STATENS KÄRNKRAFTINSPEKTION
Swedish Nuclear Power Inspectorate

Sixth HYDROCOIN workshop

Re: Level2/Case4 output format change

Addendum to HYDROCOIN Level 3 Case 7

- Figure 20.

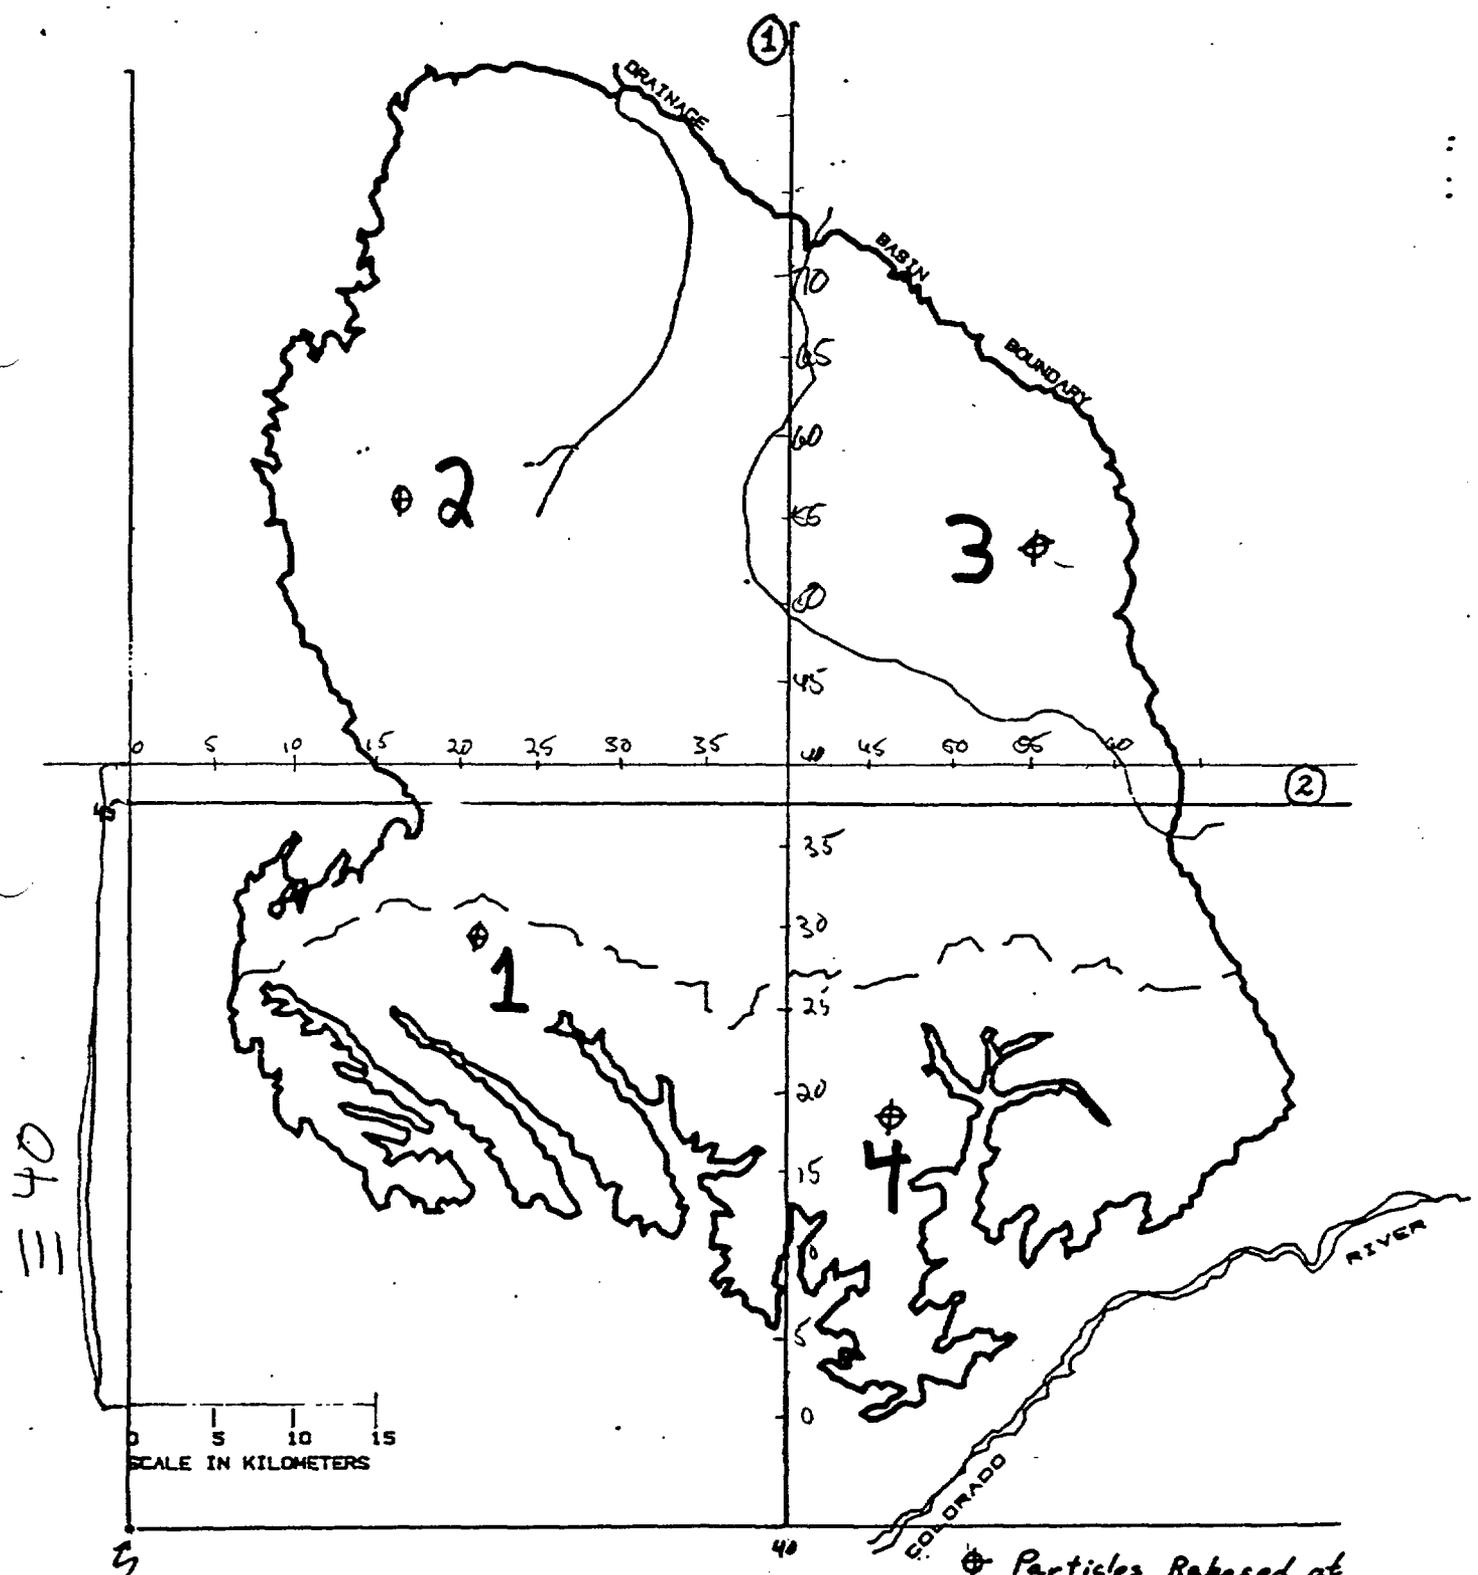
The following output format for model error and particle trajectories supercedes the format given on page 4 of the problem definition:

Line 1: Line number as shown in figure 20, FORMAT(I5)

Line 1: Layer number, Trajectory number (see enclosed figure),
Number of points, FORMAT(3I5)

Figure 1 - Calculated Pathlines for Level 3 Case 7

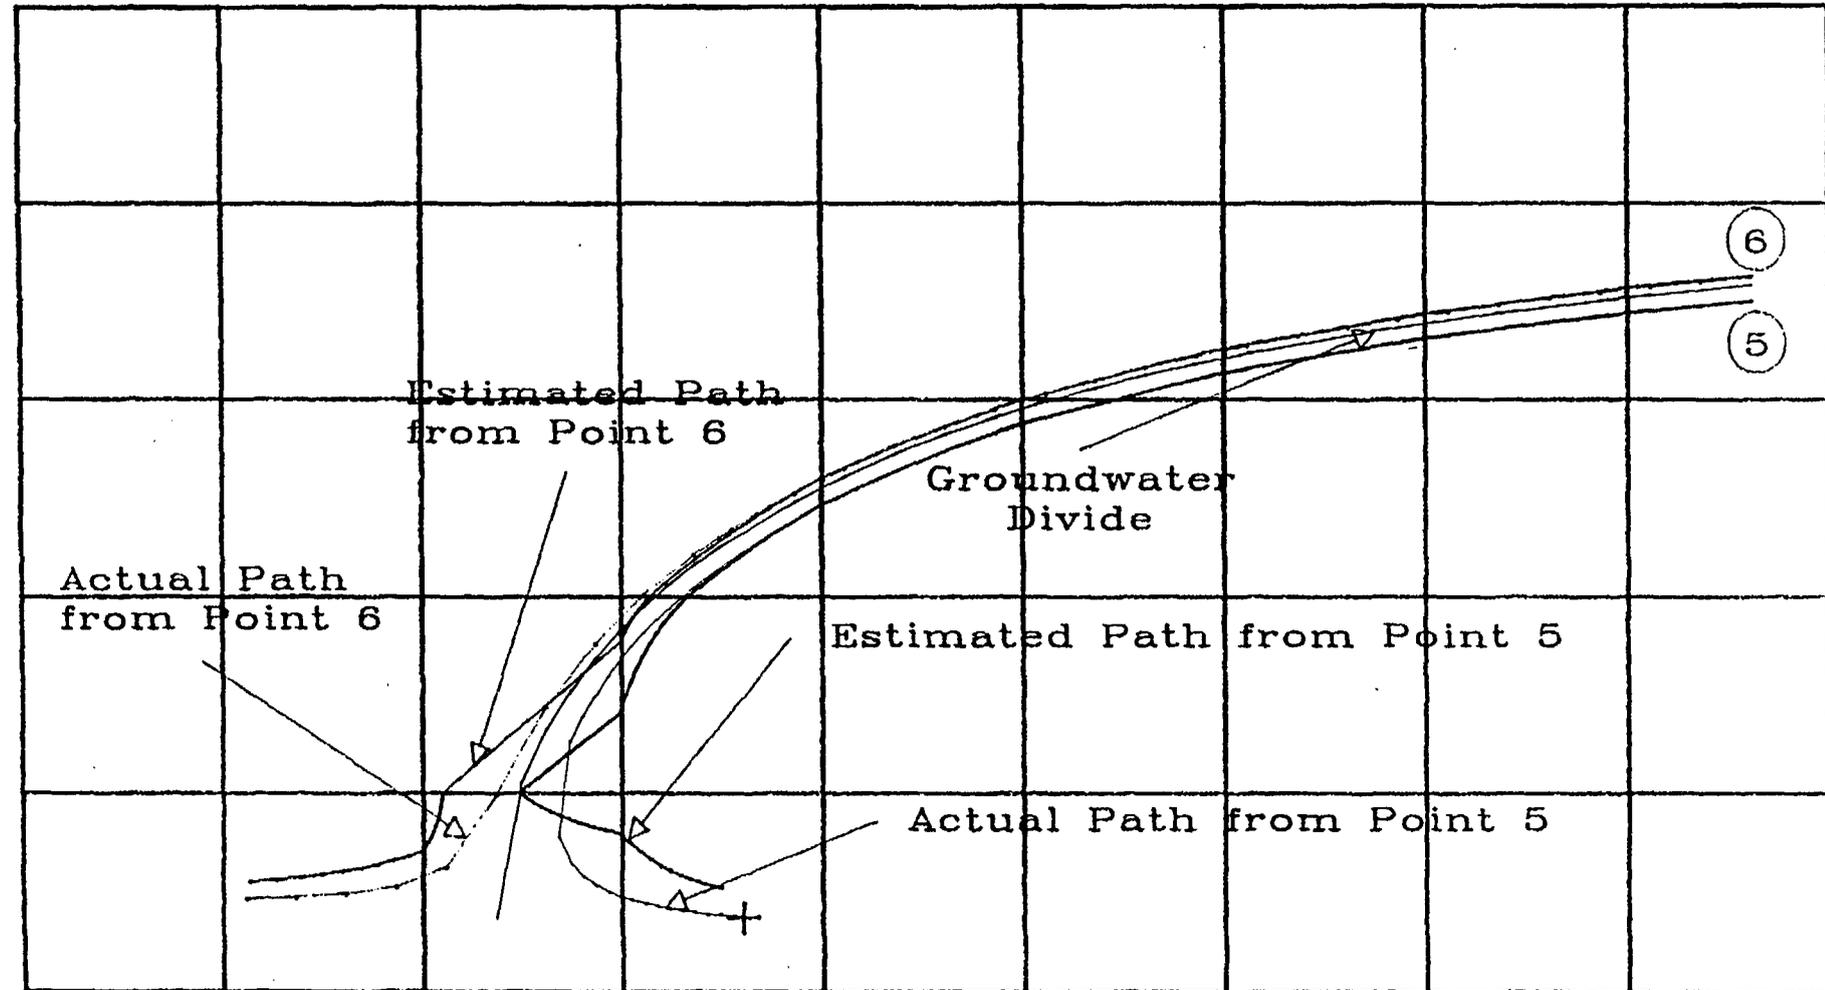
Figure 1 shows flow paths from points 5 and 6 estimated using the Sandia program TRACKER with an 80 meter grid spacing. Velocities were obtained by sampling potentials. Figure 2 shows plots of the error associated with these paths vs. accumulated path length.
